Subject: **Bid #: 7946-W3, Green Hill Park Community Garden / DPWP**

### **ADDENDUM NO. 2**

**Project:** Bid No. 7946-W3 **Greenhill Park Community Garden**  
**City of Worcester Department of Public Works and Parks**  
**Parks, Recreation and Cemetery Division**

**General Bid Clarification**

1 2' HT. (4X6' OR 12') RAISED PLANTERS, TYP  
NOT TO SCALE

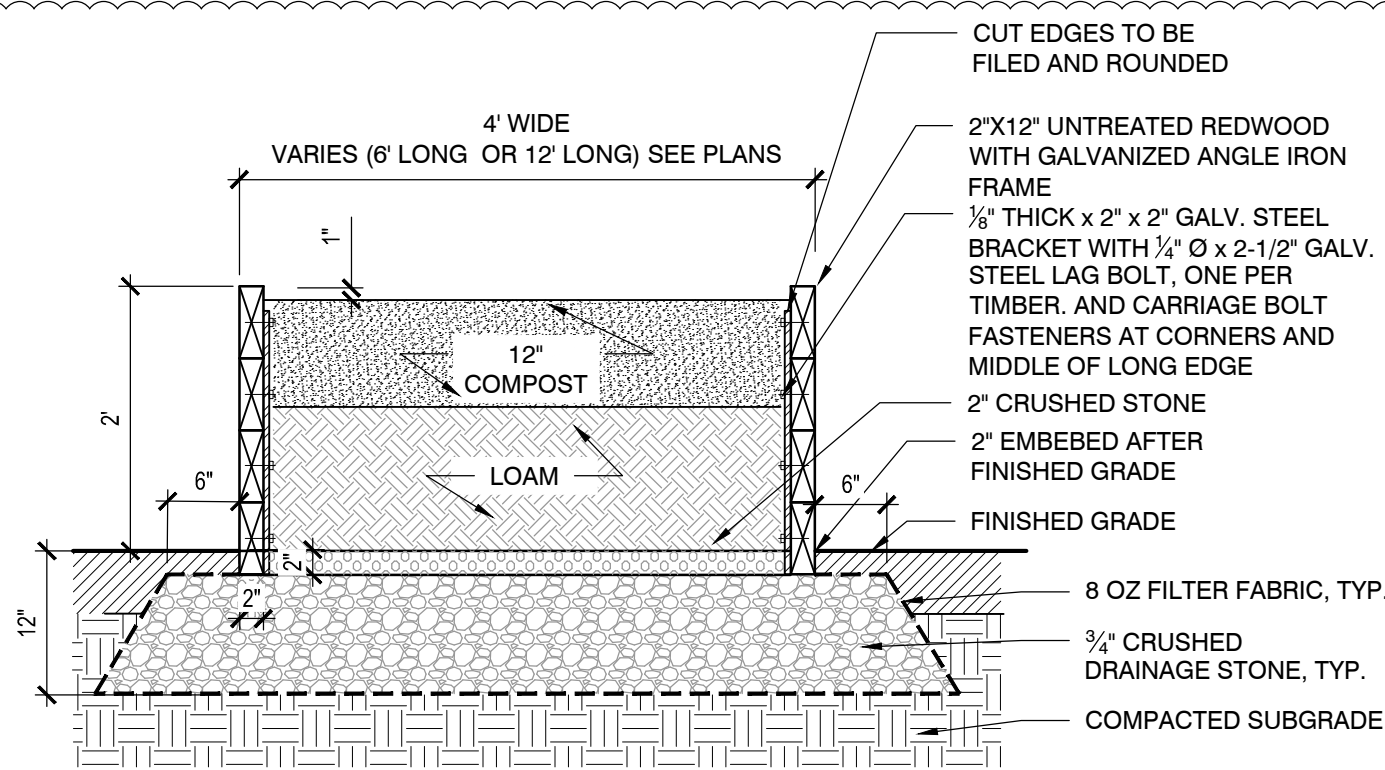
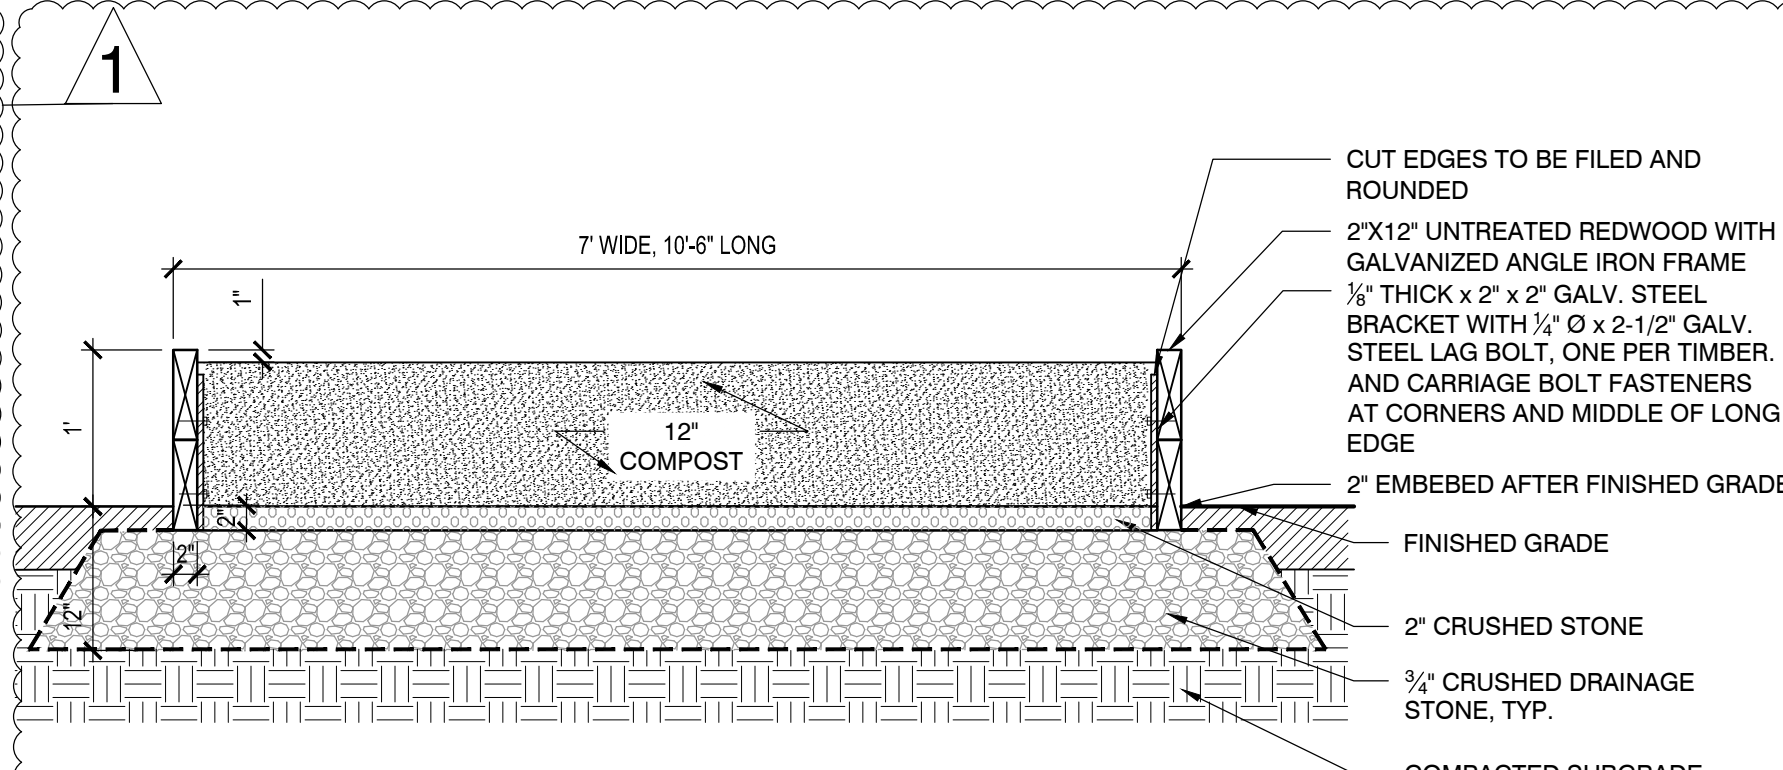
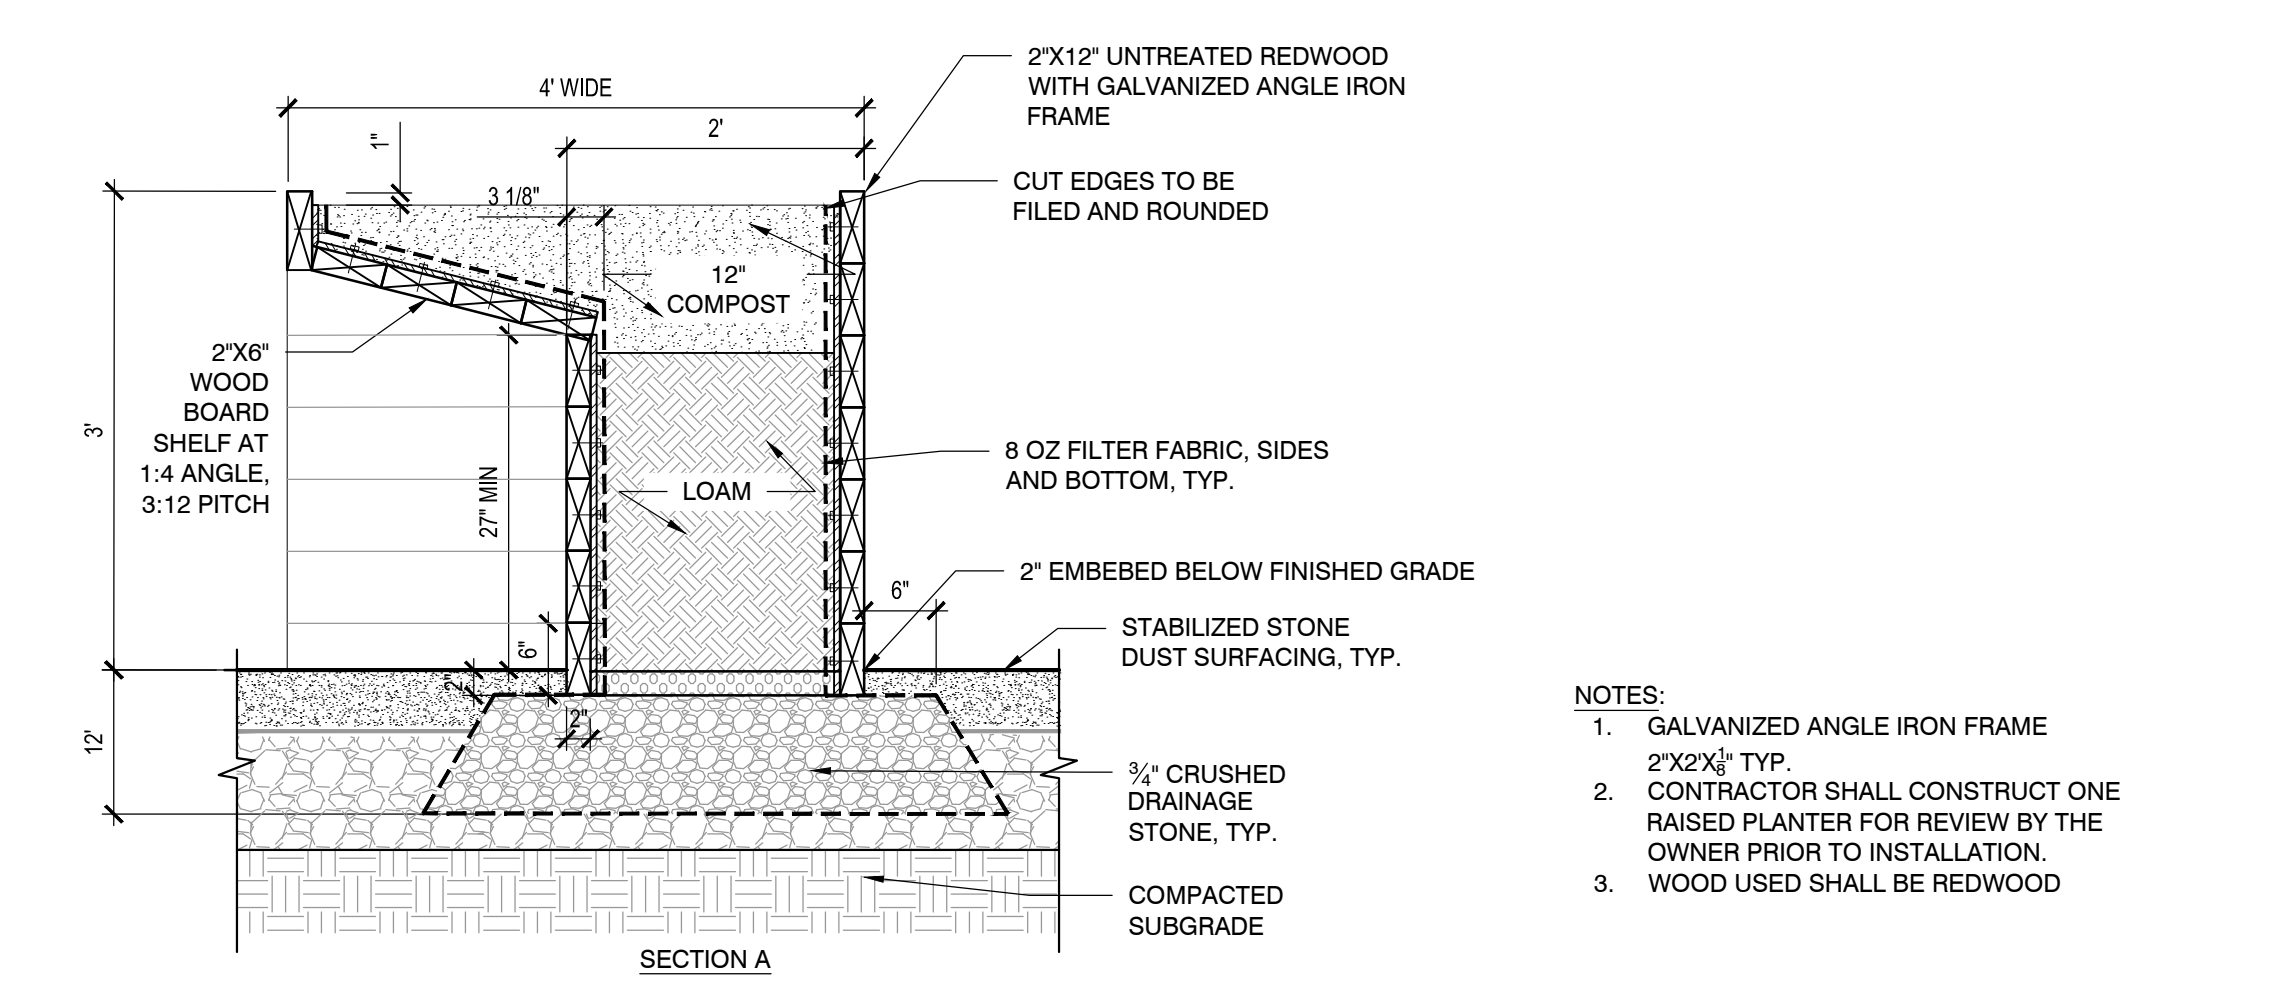
Question 7: Planter detail appears to show 2"x6" boards but is noted 2"x12". Please clarify.

Question 10: In the detail below, it refers to a flat bar brace. As its drawn it appears that the brace will wrap behind all the way around the accessible raised planter but is not shown on the cross section (to determine how many bands will be required) for the accessible planner or the other planters. Please specify.

Question 11: Please refer to Plan L120. The leaders on the left side of the plan reference only 24" Raised Planters. Are some of these planters supposed to be 12" Raised Planters? Also, the planters on Plan L120 seem to be drawn to different dimensions than what are shown on detail #1 and #2 on Plan L503. Please clarify quantity and size of planters.

**Answer 7:** Confirmed. Please follow the planter detail callouts (2"x12"). Details drawings not to scale. Please see attachment 'L503 Construction Details'.

**Answer 10:** Confirmed. Please use galvanized steel brackets, and not flat bar braces. Please see attachment 'L503 Site Construction Details'.

**Answer 11:** Please refer to revise drawings. See attachments 'Materials Plan L120' and 'Site Construction Details L503'.

4 YARD HYDRANT, TYP.  
NOT TO SCALE

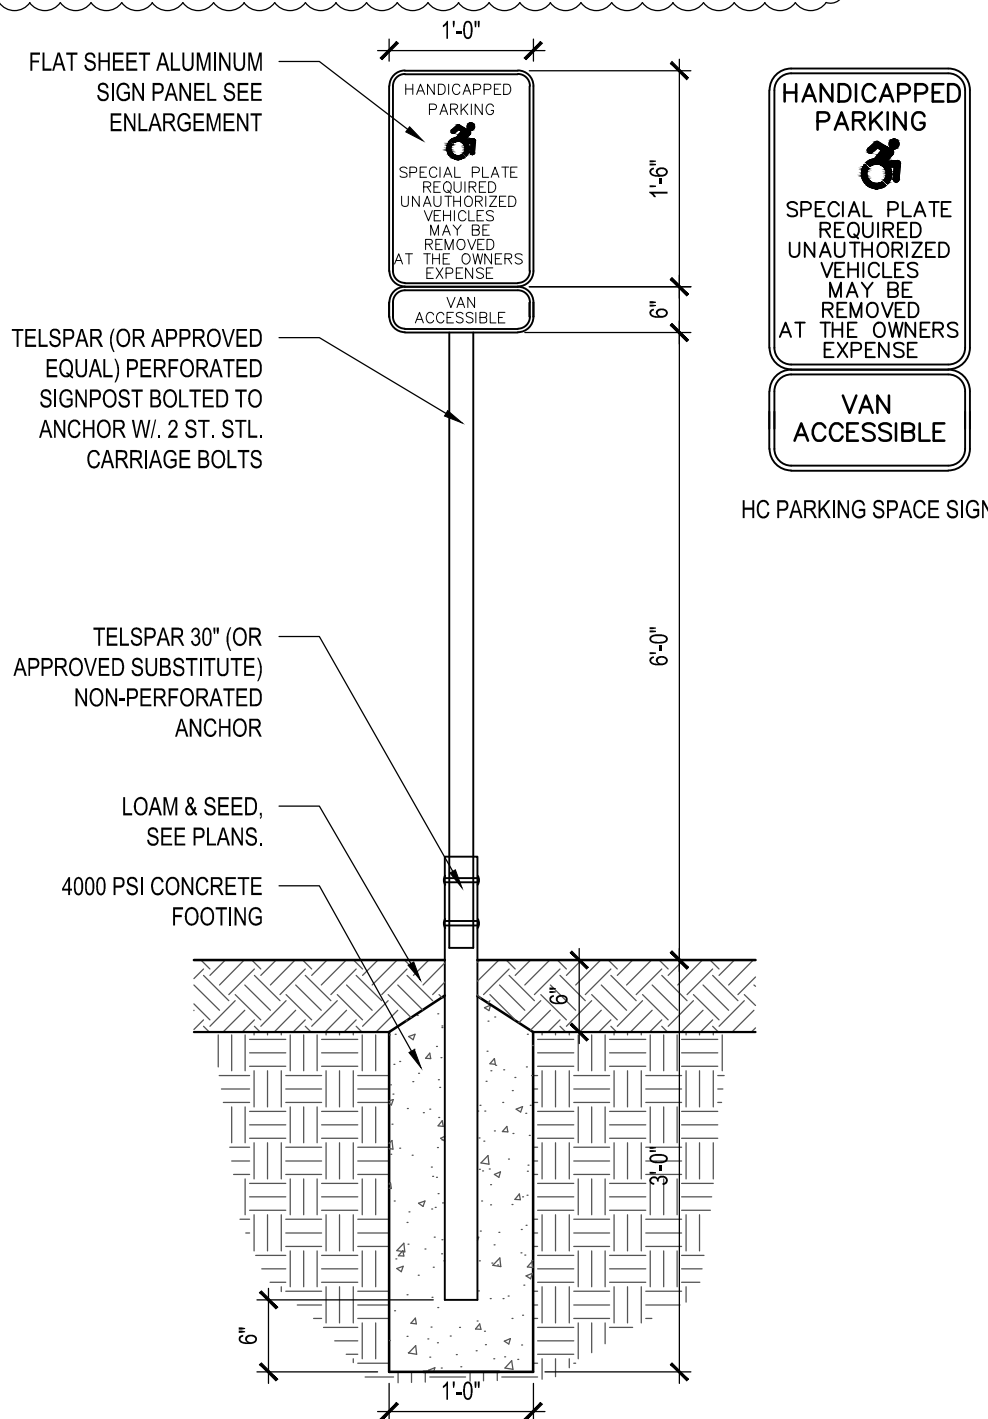
Question 18: The Yard Hydrant detail on Sheet L503 calls for an 8" square hardwood post in the bottom detail but calls for a hollow 6" diameter post in the top detail. Please clarify which is to be provided.

**Answer 18:** Please use 6" diameter for pipe and 8" for square hardwood post.

7 FOUNDATION AT GREENHOUSE  
NOT TO SCALE

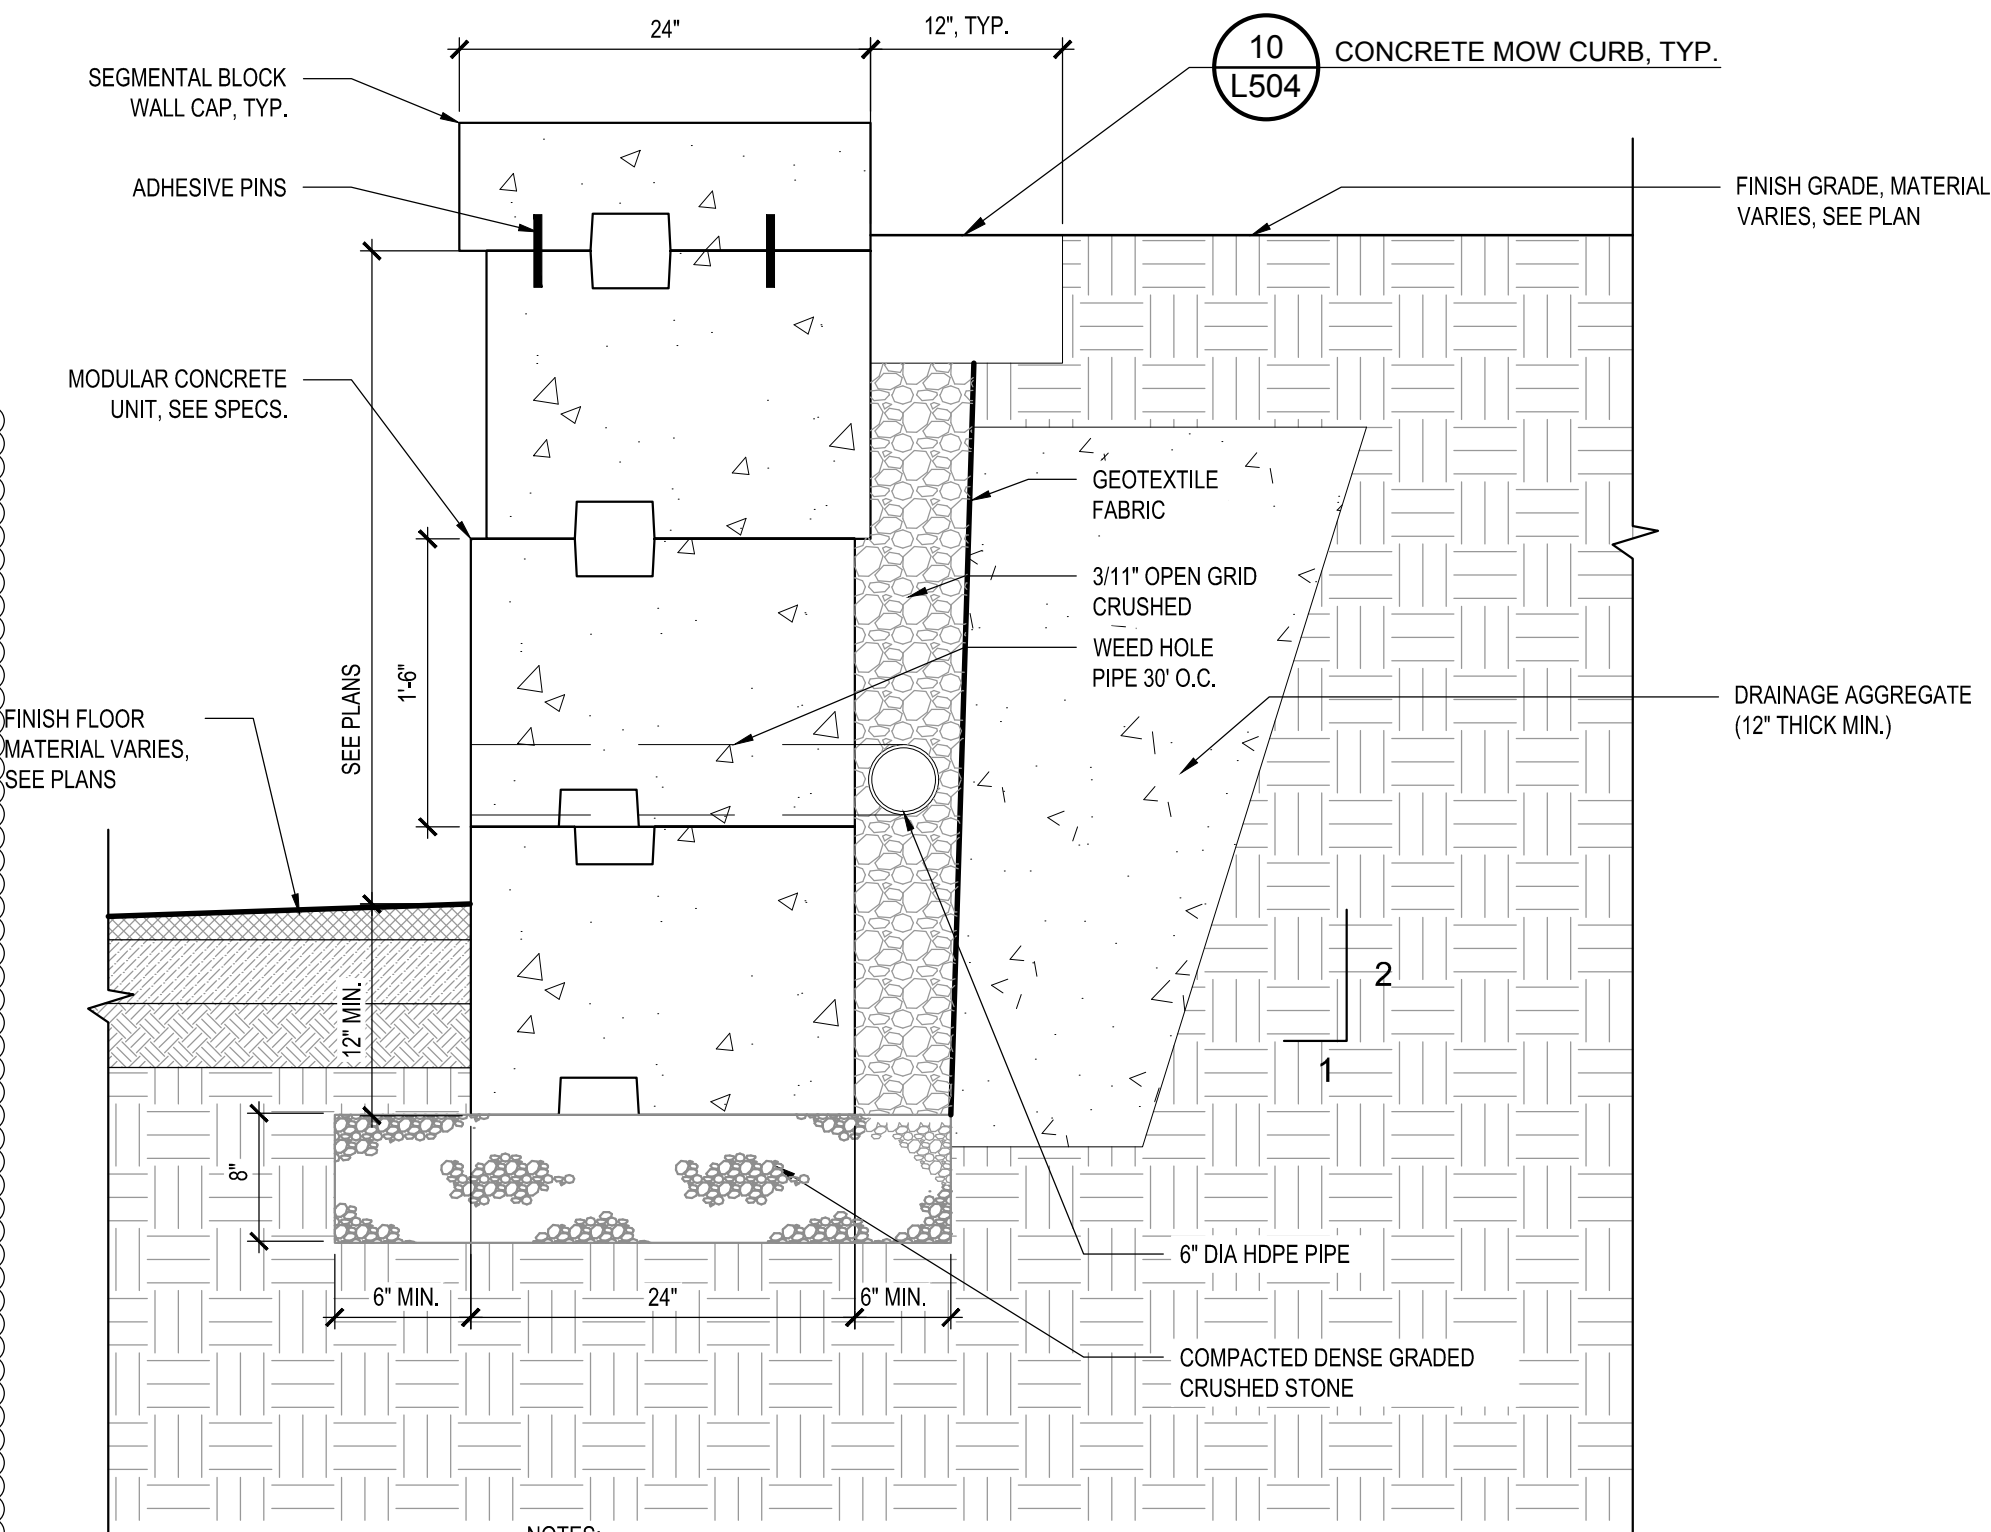
Question 12: Detail #7 on Sheet L503 shows the foundation required for the Greenhouse. The width of the footing is not called out. Please provide the width of the footing and stem for the greenhouse foundation.

Question 13: Please provide reinforcing details for the 6" greenhouse slab on Detail #7 on Plan L503.

**Answer 13:** Please refer to revise drawing. See attachment 'L503 Site Construction Details', detail #7.
